***Lot 2 DP 748682
132-138 Killeaton Street, St Ives***

***MP10_0057 MOD 4 – Modification to Amend
RLs and Rooftop Areas***

Director-General's
Environmental Assessment Report
Section 75W of the
Environmental Planning and Assessment Act 1979

Figure 2 – Site Plan of Stage 2, comprising buildings A, B and C fronting Killeaton Street. The location of the proposed rooftop plant rooms and pergolas are indicated in red. The setbacks of the proposed rooftop plant rooms to the edges of the buildings are indicated in green.

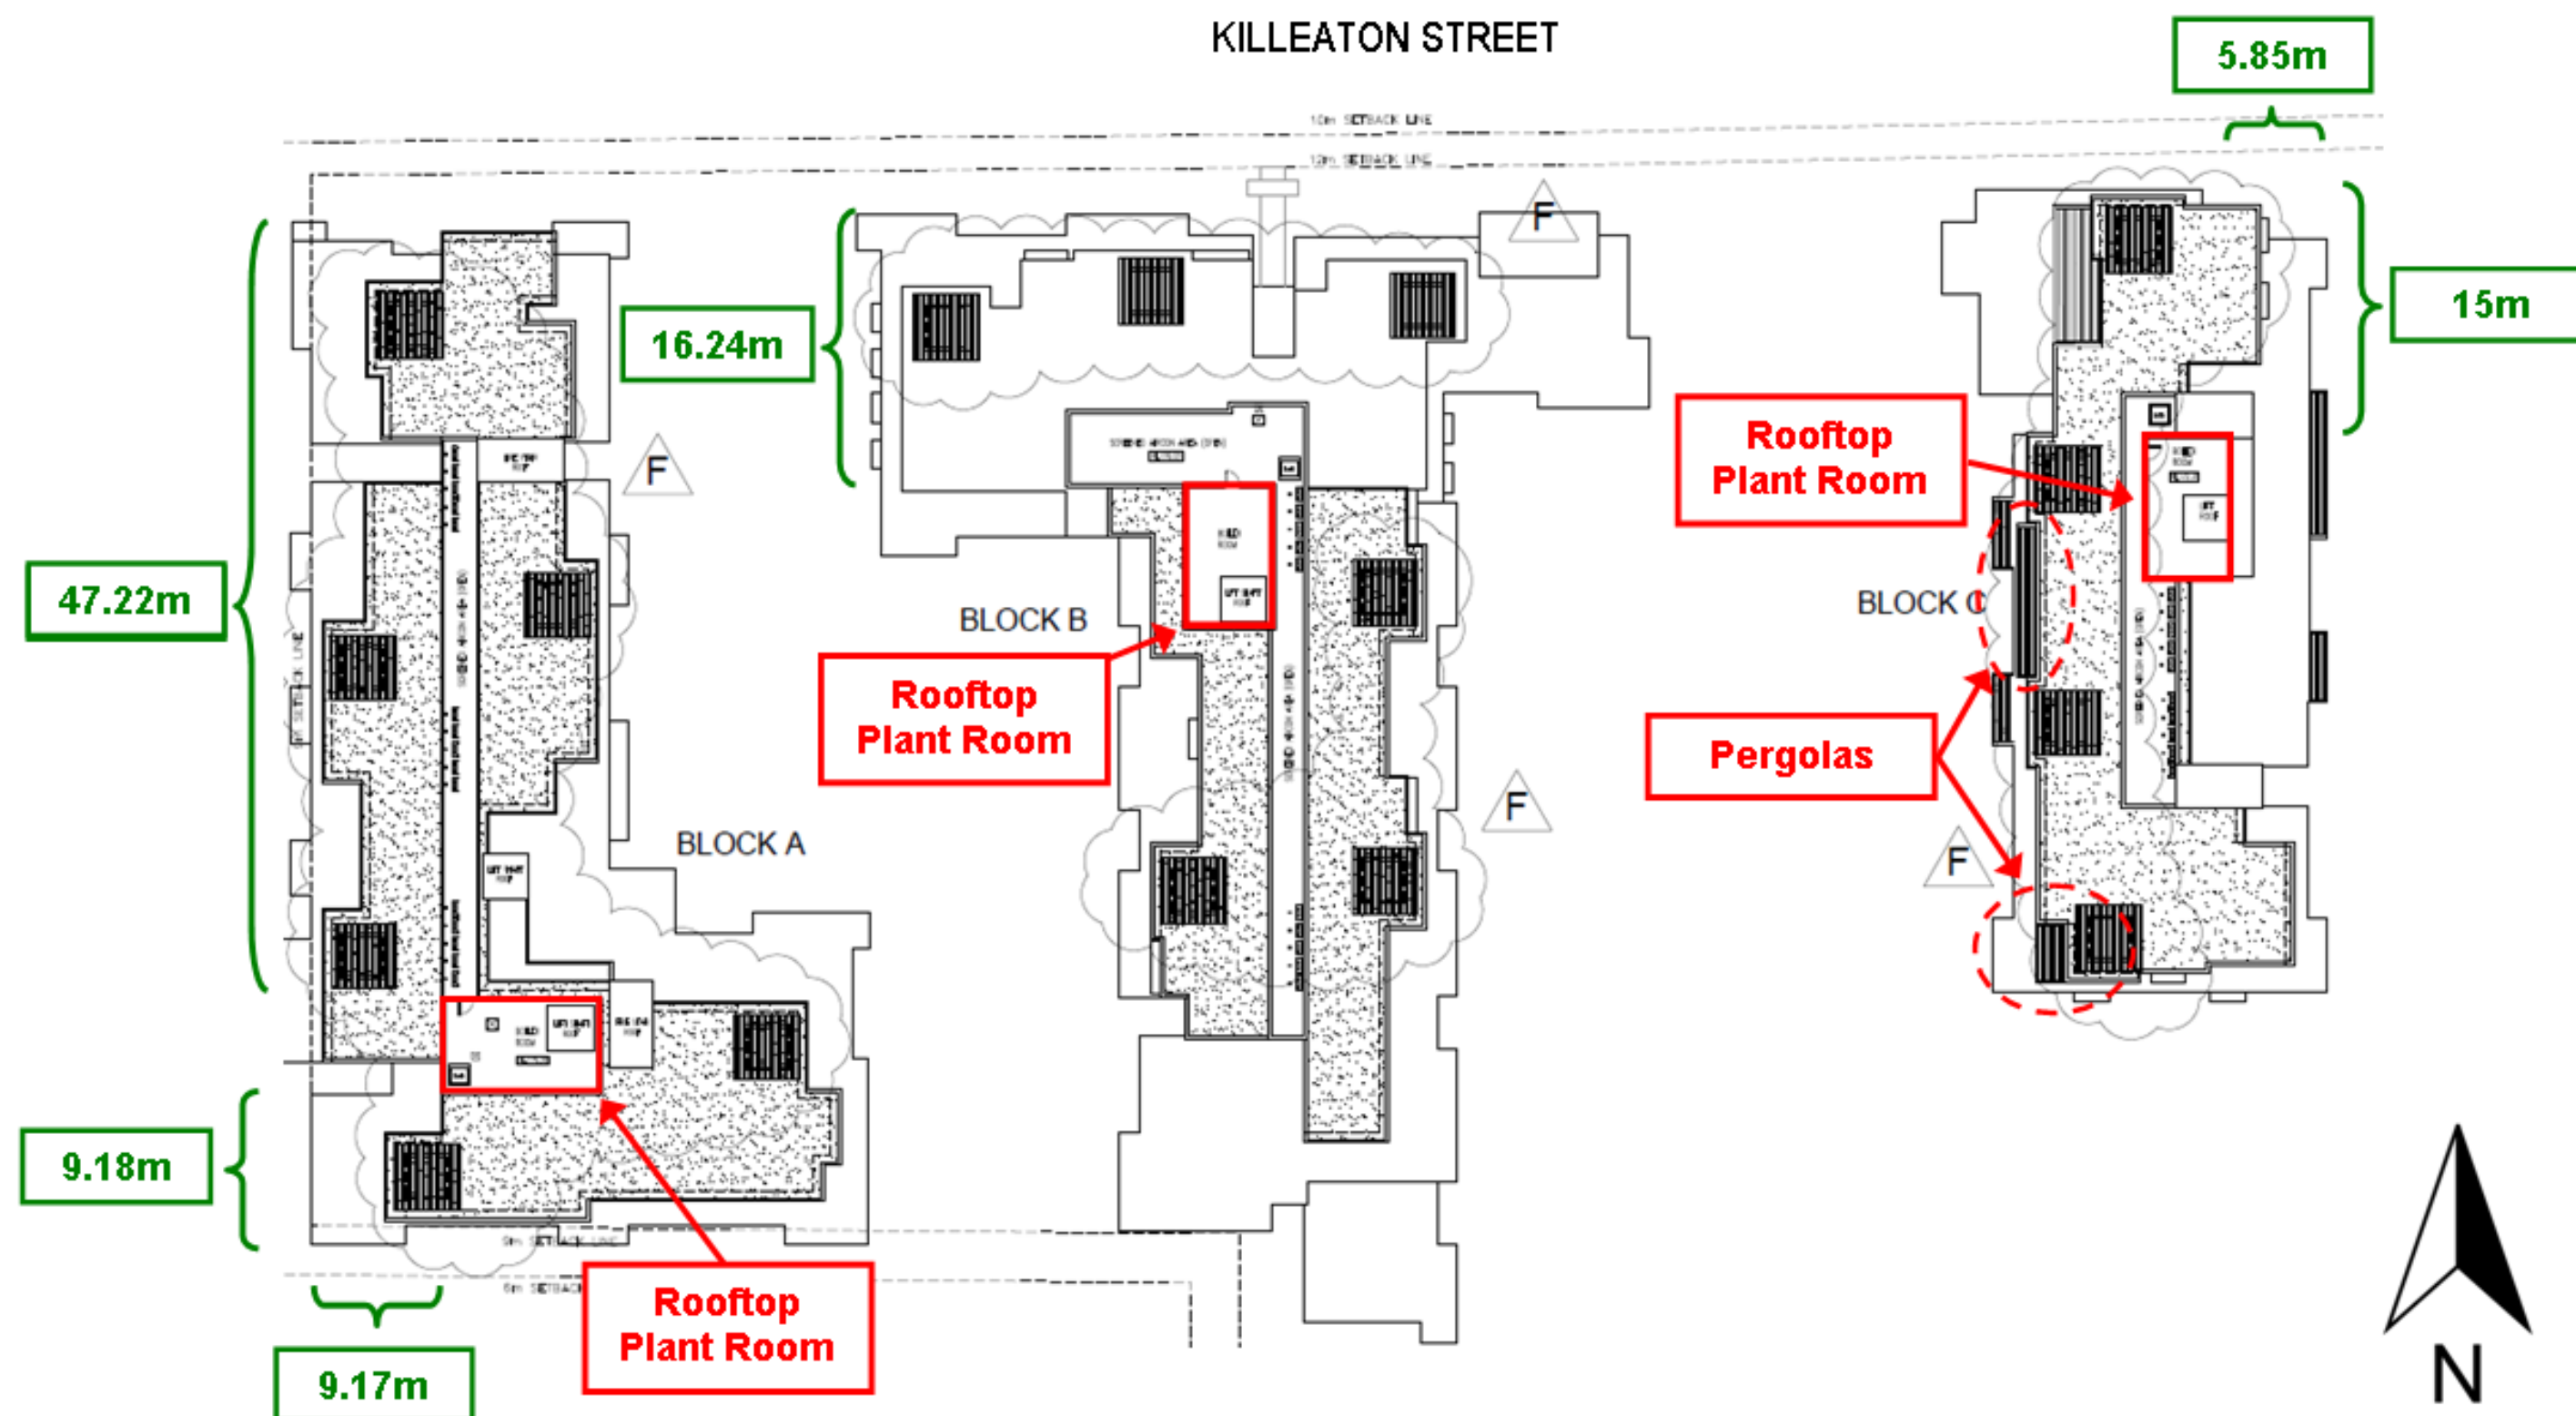
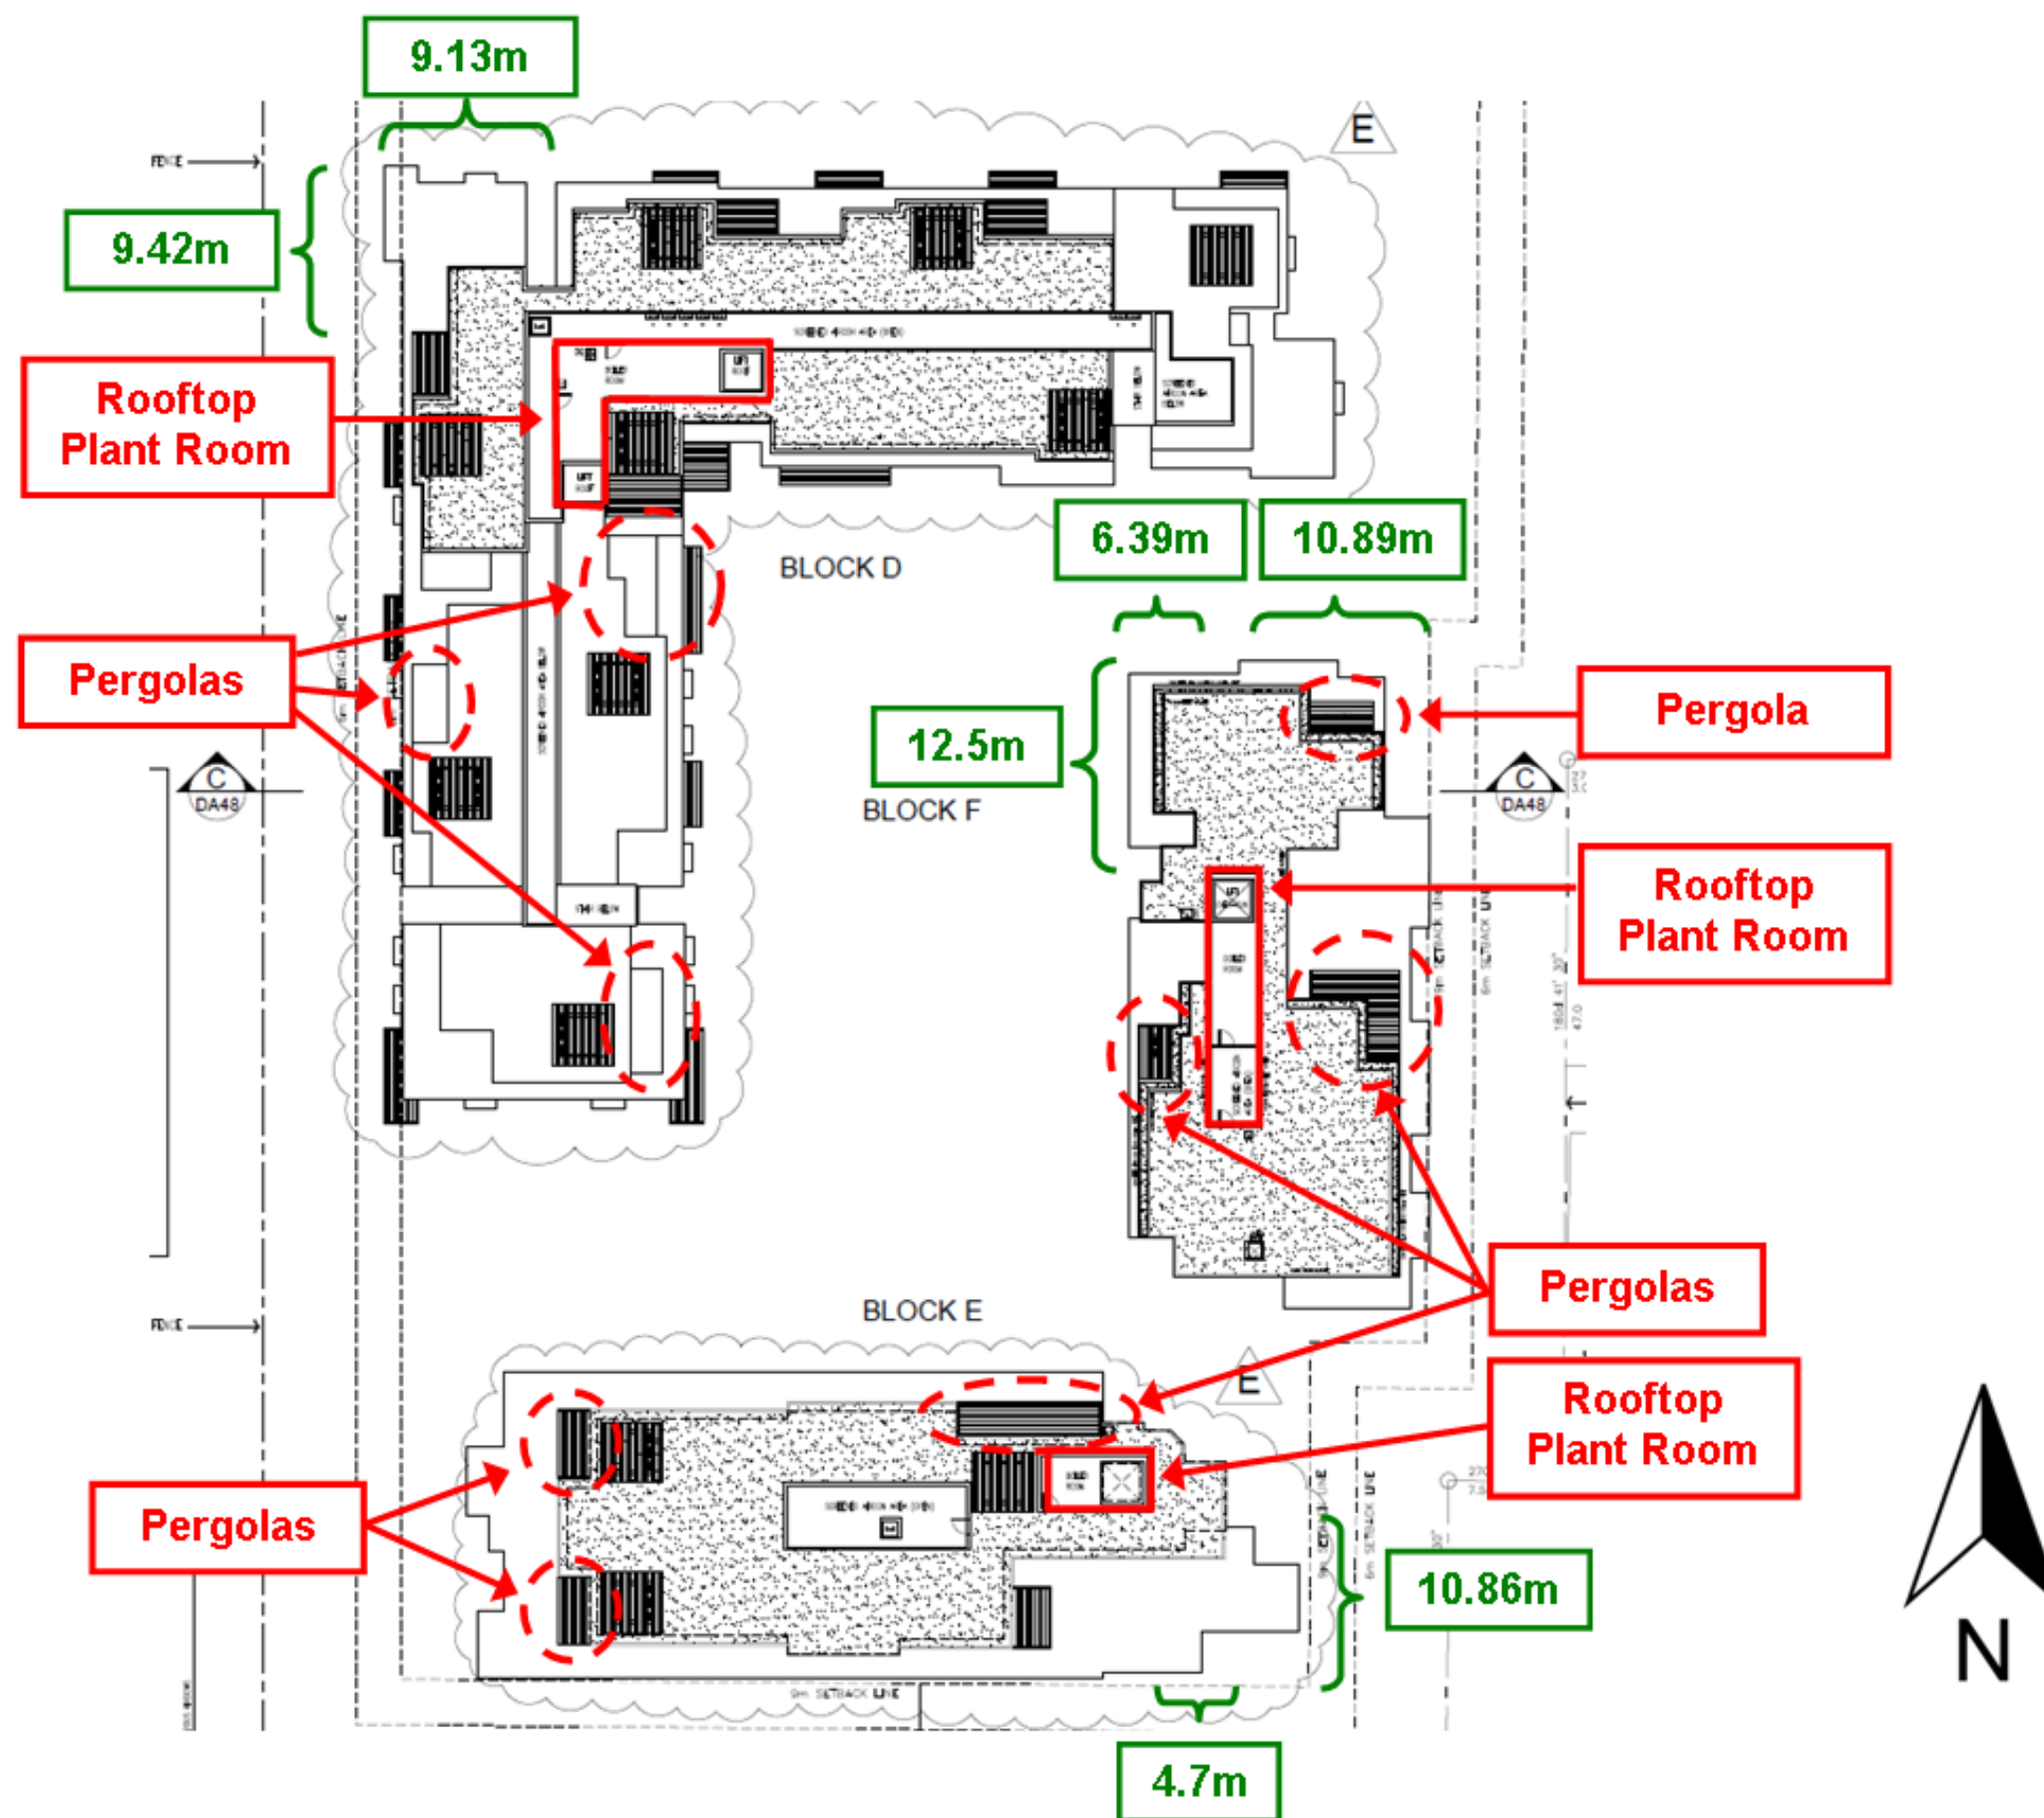
The proposed rooftop plant rooms contain hot water heaters and lift overruns for each block. Each rooftop plant room is located toward the centre of the roof area (refer to **Figures 2** and **3** above) and is screened by louvres 2.5 metres in height with enclosed walls and ceilings as shown in **Figures 4** and **5** below.

The rooftop plant rooms are not anticipated to be readily visible from the public domain due to their setback from the building edge and location toward the centre of the roof area for each building (refer to **Figures 2 and 3** above). The photomontages showing Block B as viewed from Killeaton Street in **Figures 6 and 7** below, demonstrate that the rooftop plant rooms sit comfortably within the scale of the approved building form and are not readily visible from the public domain. As demonstrated in **Figure 5** above, the rooftop plant rooms are in keeping with the scale of the buildings and are well set back from the side boundaries which are also lined with mature trees. The department considers that these plant rooms will not be readily visible to the adjoining properties therefore will not adversely affect the amenity of these properties. The department therefore considers the proposed rooftop plant rooms to be appropriate and will not appear as an additional floor.

Figure 4 – Proposed north elevation of Block B fronting Killeaton Street indicating the approved 1.1m screening for the air conditioning units and the proposed rooftop plant room and associated screening.

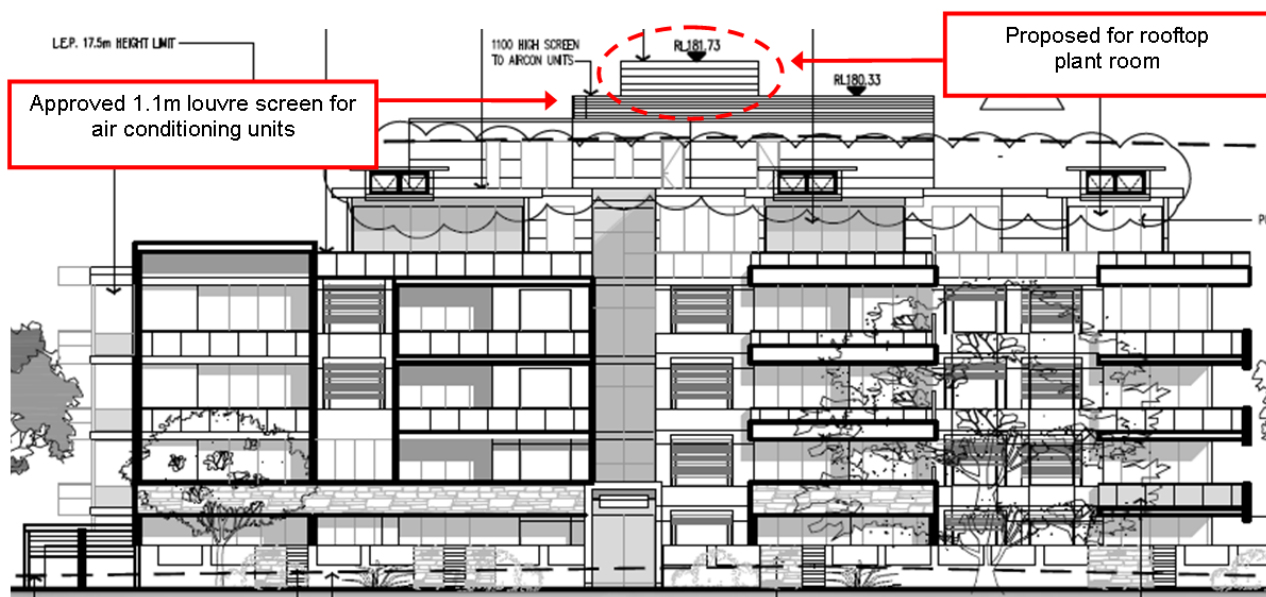
Council has raised concern that the proposed rooftop plant rooms are interpreted as an additional storey under the KPSO and as a result Blocks A, B, D and E do not comply with the maximum height restriction.

The additional height is from 0.75m to a maximum of 1.49m, and is not a floor in reality and the department considers that in determining the appropriateness of the rooftop plant room the key issue is whether these structures will be readily visible to adjoining properties and the public domain.

Figure 8 – Plan demonstrating the approved western elevation of Block A. The approval included four skillion-style skylights visible from this elevation.

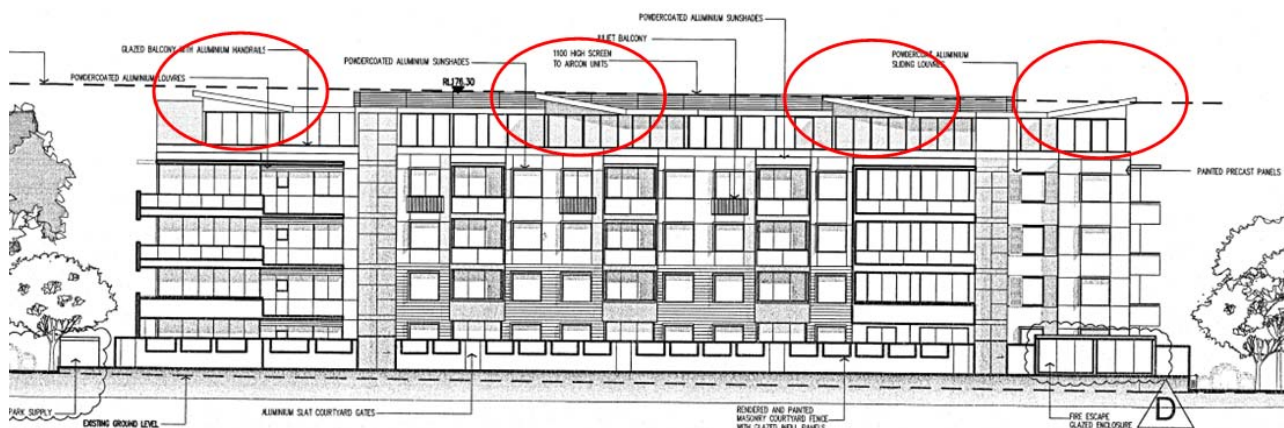
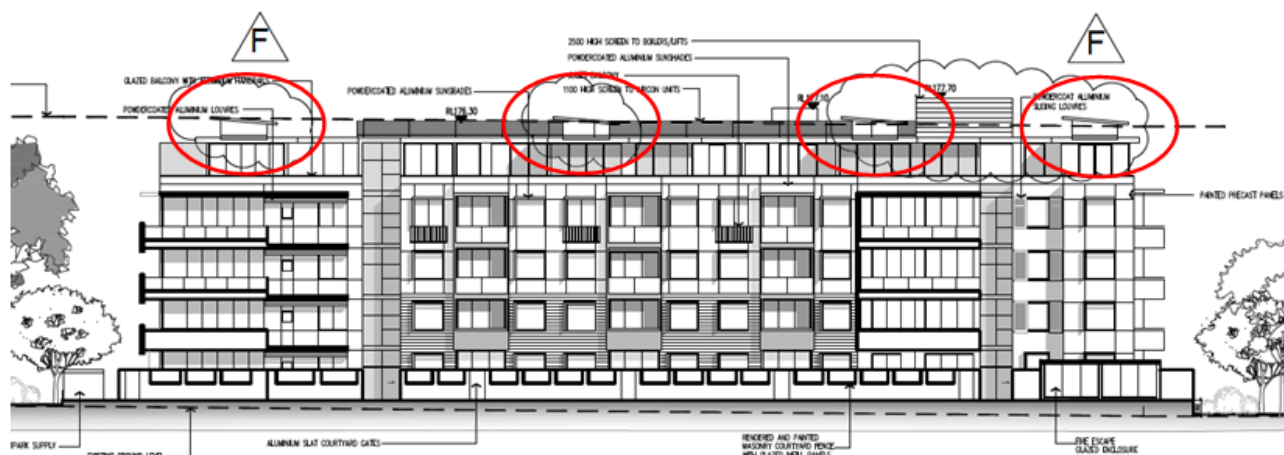
Council has raised concern that the proposed redesigned skylights change the appearance of the development as demonstrated in **Figures 8** and **9** below.

The department considers that the proposal to modify the approved skylight design will not significantly alter the appearance of the approved building (**Figures 8** and **9**). The department notes that the general size and location of the skylights is maintained with the modified design. The department considers that this proposed design maintains the intent of the Residential Flat Design Code as it reduces the reliance on artificial light and improves energy efficiency and residential amenity. As a result, the department supports the amended skylight design.

Figure 10 – Level 3 Floor Plan demonstrating the proposed location of three pergolas to Block F.

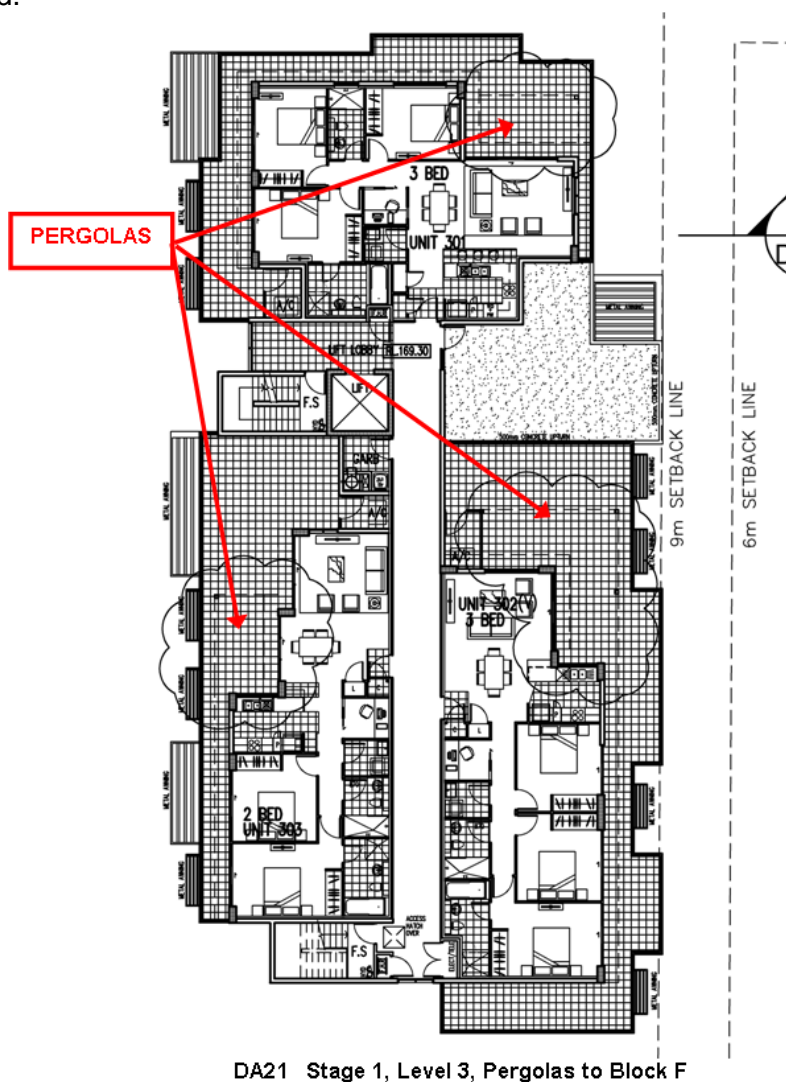
The proposed addition of pergolas for eleven top floor apartments reflects the intent of the Residential Flat Design Code as it enhances the residential amenity for future occupants by providing shading and glare control for these private open space areas. The pergolas are considered to be minor light-weight additions that are consistent with the approved ceiling heights, will match the approved colours and materials of the development, and are in keeping with the
